Product / Process Change Notification (PCN)	
<input type="checkbox"/> Major change <input checked="" type="checkbox"/> Minor change	
PCN #: PCN_FrqXTAL_20230301 Affected Series: WE-XTAL; 830025159 PCN Date: December 01, 2022 Effective Date: March 01, 2023	Change Category: <input type="checkbox"/> Equipment / Location <input type="checkbox"/> General Data <input type="checkbox"/> Material <input type="checkbox"/> Process <input type="checkbox"/> Product Design <input checked="" type="checkbox"/> Shipping / Packaging <input type="checkbox"/> Supplier <input type="checkbox"/> Software
Contact: Product Management Phone: +49 (0) 7942 - 945 5001 Fax: +49 (0) 7942 - 945 5179 E-Mail: pcn.eisos@we-online.com	Data Sheet Change: <input type="checkbox"/> Yes <input checked="" type="checkbox"/> No Attachment: <input type="checkbox"/> Yes <input checked="" type="checkbox"/> No
Description and purpose of change: <p>To improve the processability, Würth Elektronik will change the dimensions of the carrier tape. All products with date code 2022-10-14 or later, will be affected by this change. There will be no change in form, fit, function, quality or reliability of the product.</p>

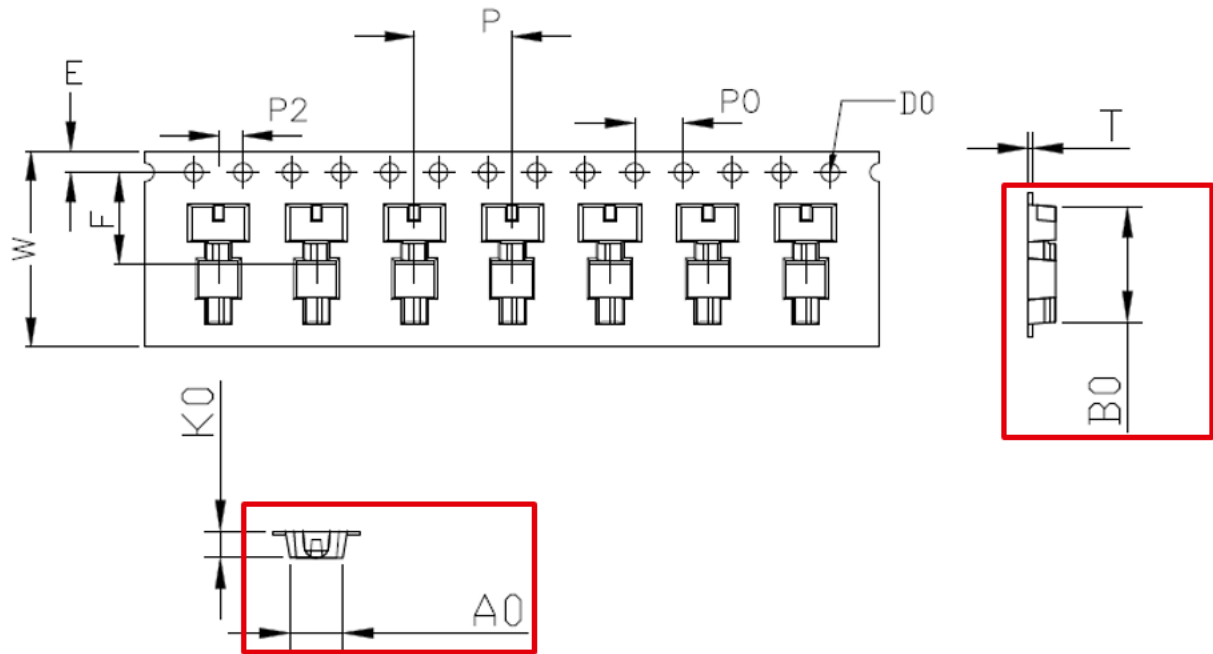
Detail of Change: <p>To prevent the product from getting stuck in the tape, the dimension of the tape cavity is changed.</p>

Before Change	After Change
A0	4.30±0.10 mm	4.50±0.10 mm
B0	9.40±0.10 mm	9.55±0.10 mm
